Project Title:
ELGIN FIRE STATION
TOWNSHIP OF RIDEAU LAKES
32 Halladay St,
Elgin, Ontario

Drawing Title:
CISTERN DECOMMISSIONING
PLAN VIEW &
SECTION

Design: BC	Checked: BC	Approved: BC	Project No.: 11807
Drawn: ZB	Checked: BC	Date: 2024-12-10	Contract No.:
Scale: 0 10'-0" 20'-0"	Drawing No.: S1		
Horizontal: 1/16" = 1'-0"			
Vertical: 1/16" = 1'-0"	REV DATE: 12/19/2024

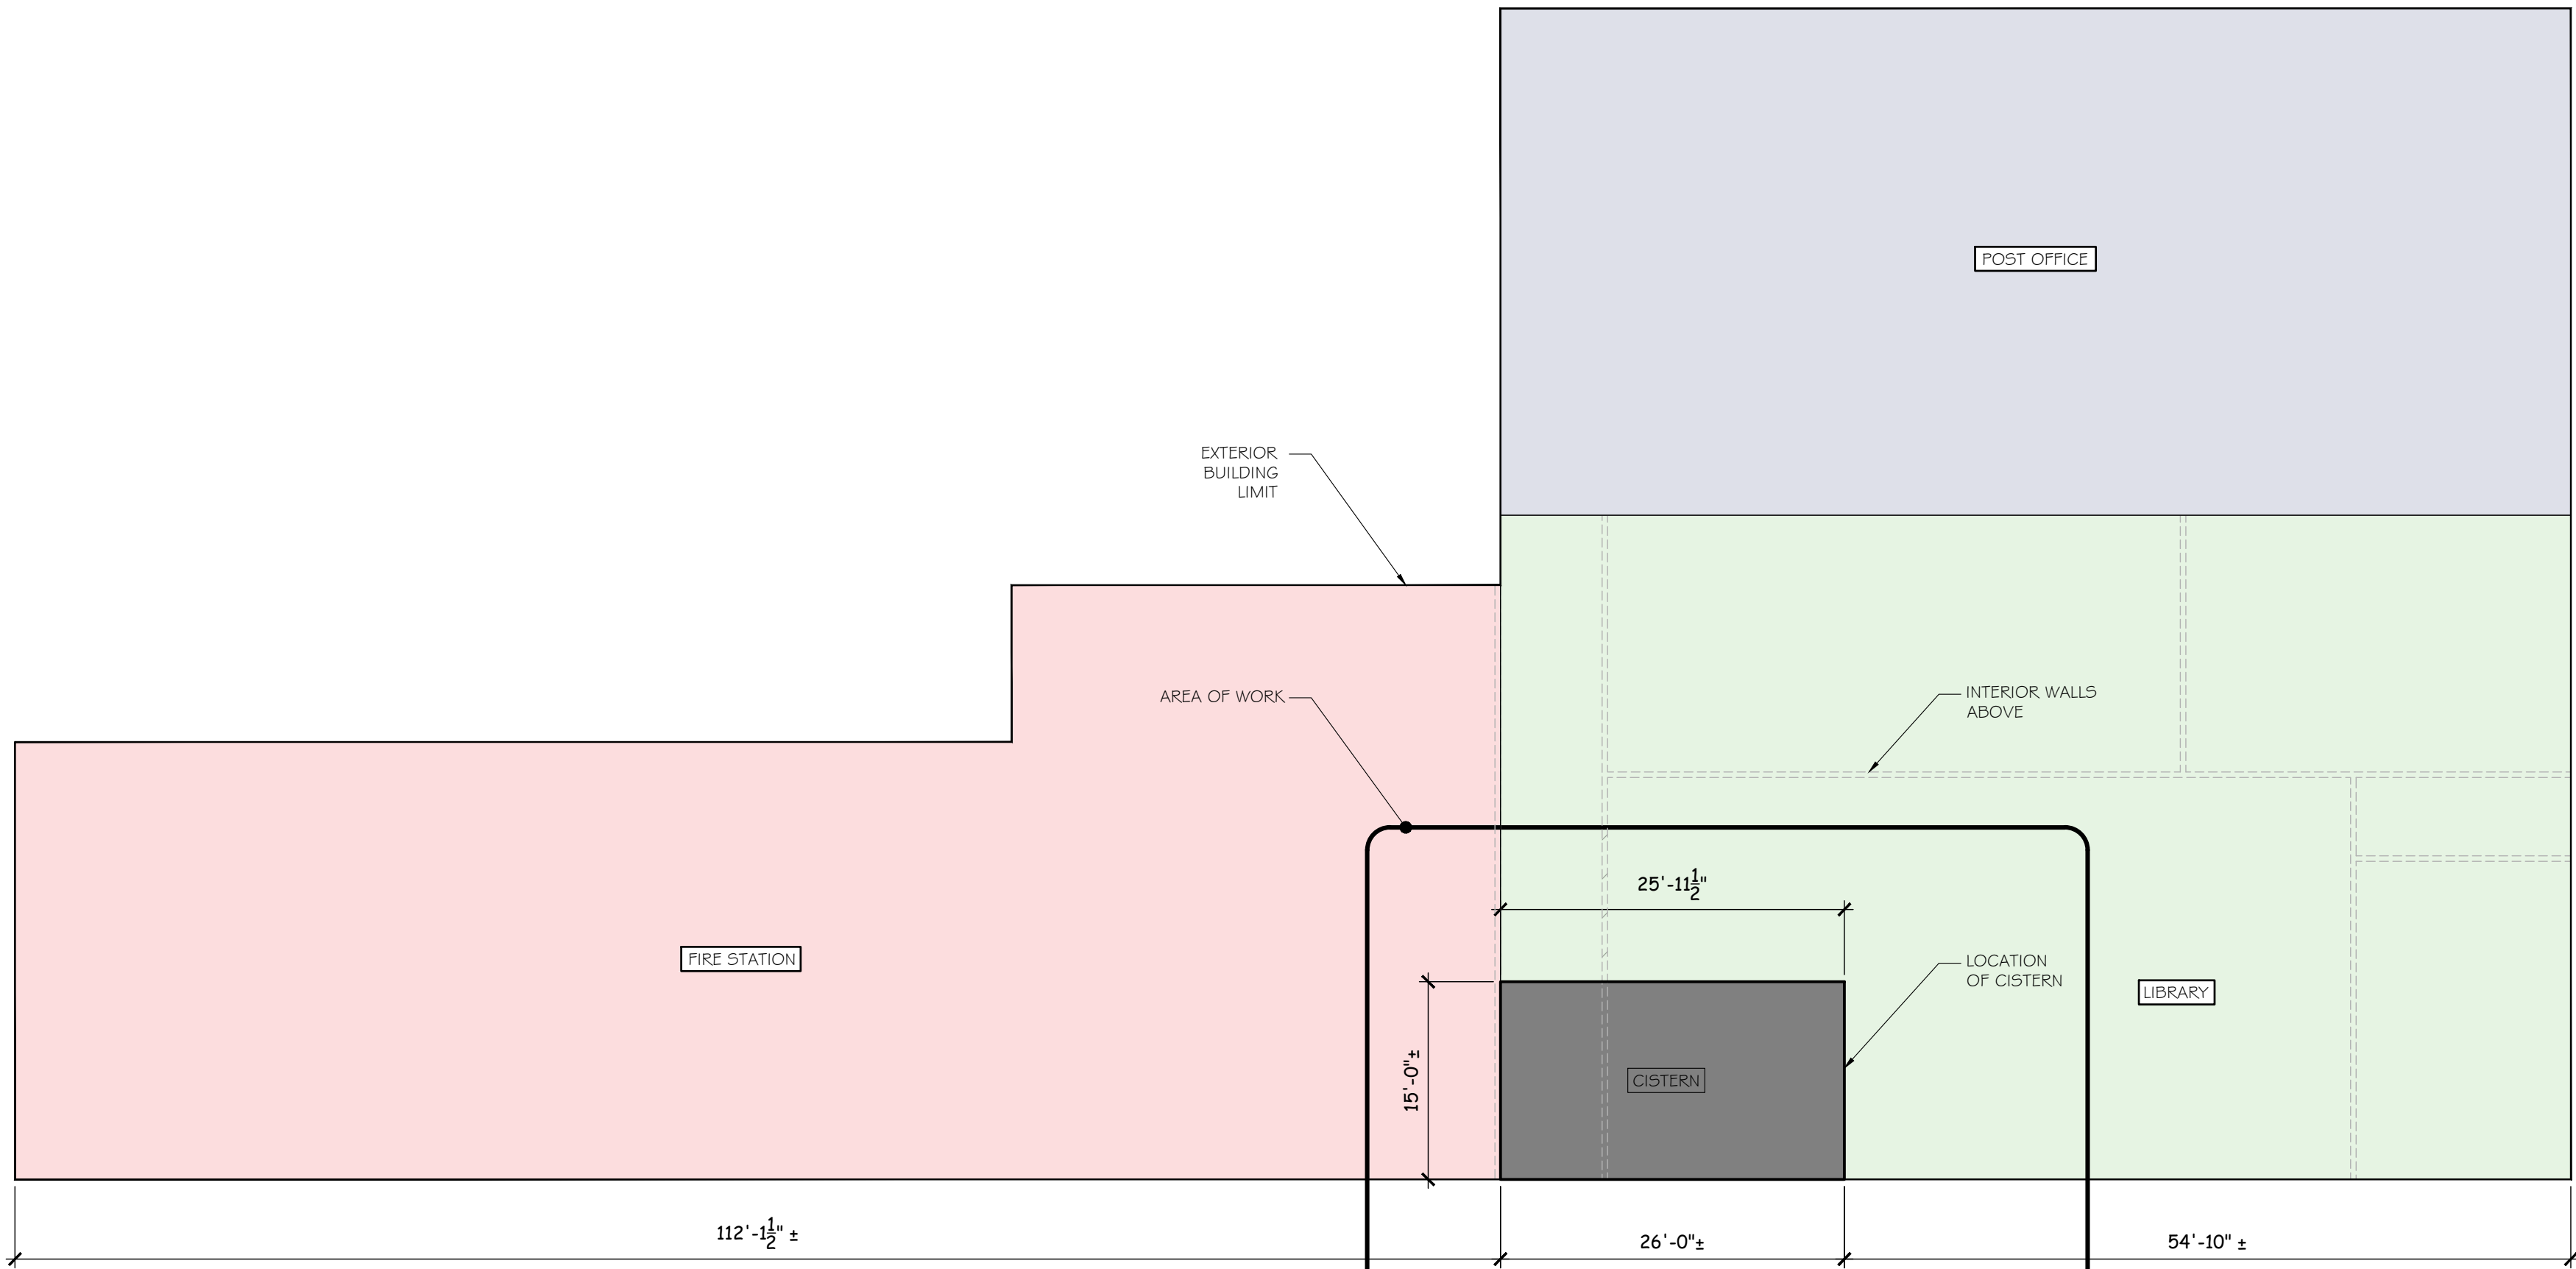
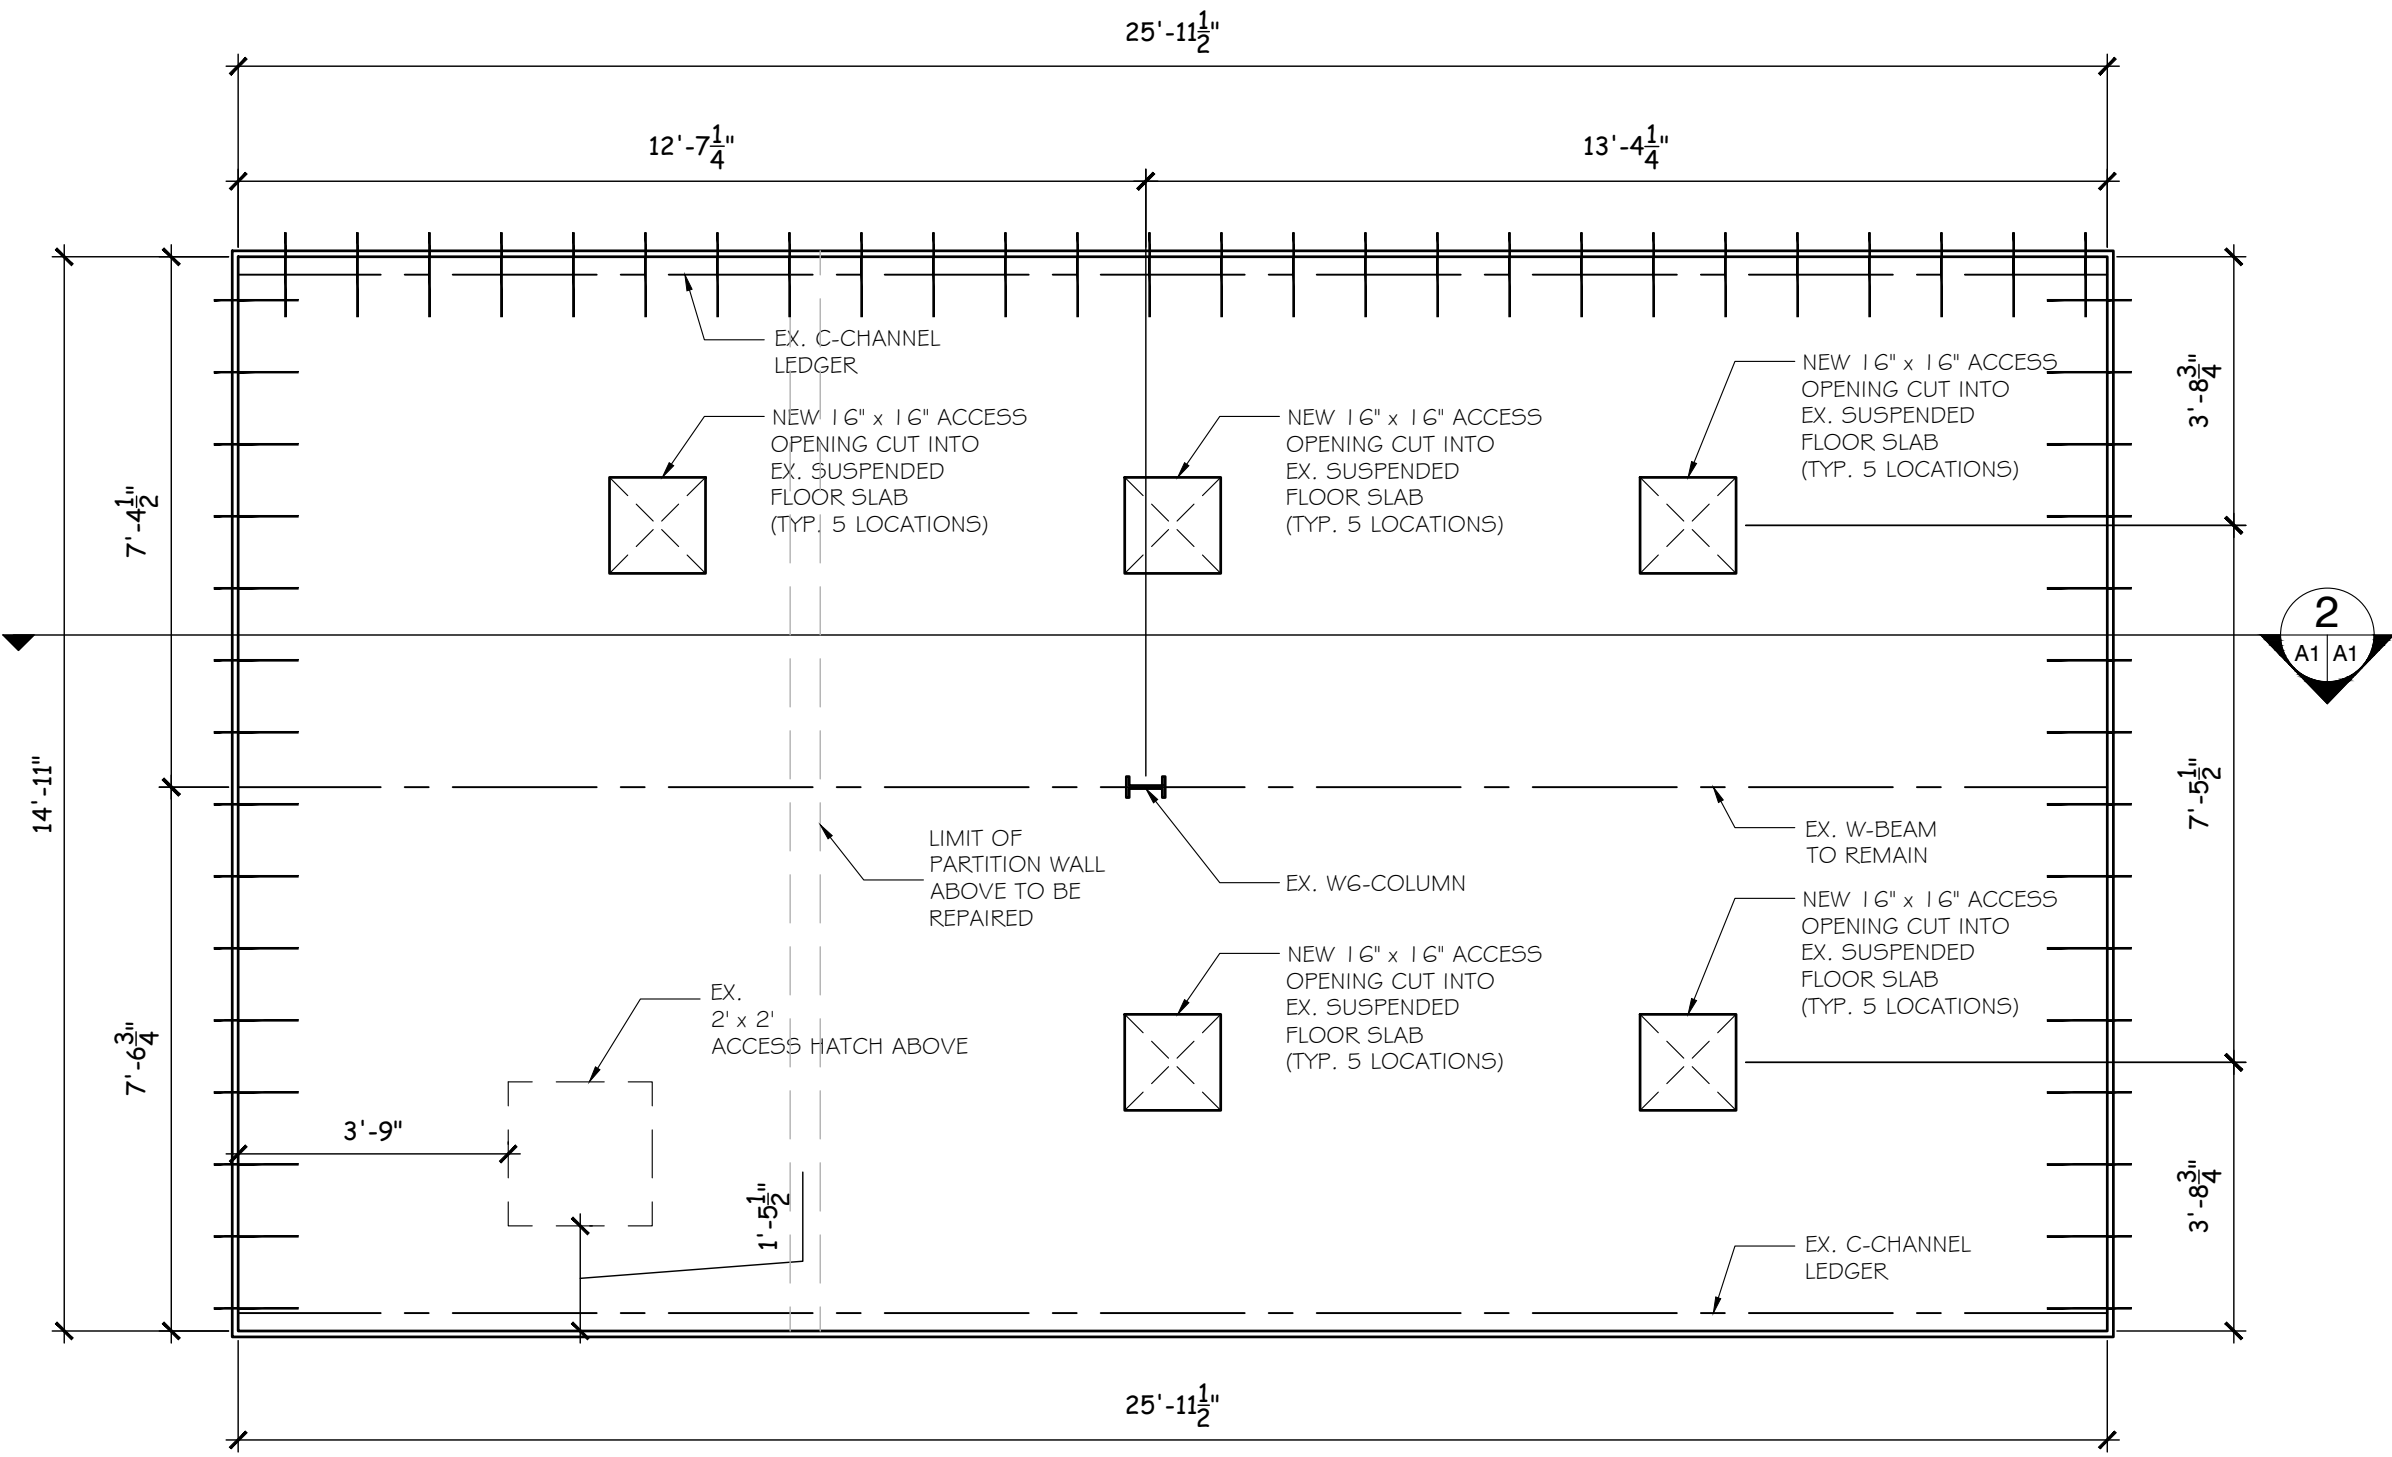
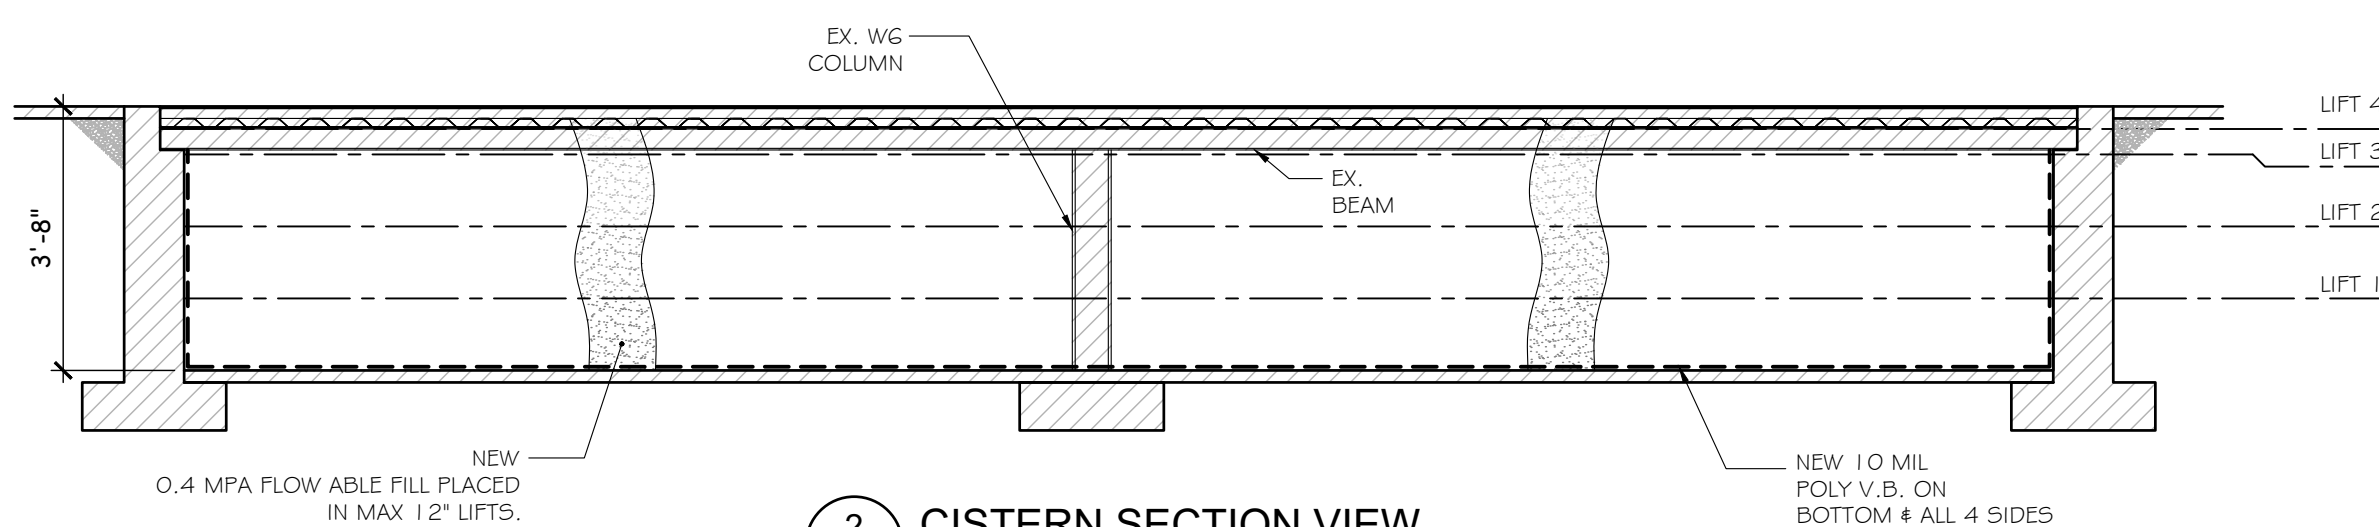
CONCRETE NOTES SEE REVISED SCOPE OF WORK

- CONCRETE ADMIXTURES SHALL NOT CONTAIN CHLORIDES.
- SUBMIT CONCRETE MIX DESIGNS TO DESIGNATED ADMINISTRATOR FOR REVIEW BEFORE START OF WORK.
- ~~INTERIOR SLAB APPLICATIONS:~~

- ~~BACKFILL THE FIRST 3 LIFTS OF GRANULAR FLOWABLE FILL. ENSURE THAT THE STEEL BEAM AND LEDGERS REMAIN ACCESSIBLE FOR REMOVALS.~~
- ~~REMOVE THE REMAINING LIMITS OF THE SUSPENDED FLOOR SLAB NOTED AS 26'-0" x 15'-0" ±, ENSURING TO PROVIDE ACCESS TO THE EXISTING STEEL MEMBERS.~~

- ~~REMOVE BY MEANS OF CUTTING, TORCHING AND UNBOLTING EXISTING STEEL BEAMS, LEDGERS AND TOP OF COLUMN EXPOSED UNDER THE PROPOSED SLAB. REMOVE AND PROPERLY DISCARD STEEL FROM THE SITE.~~
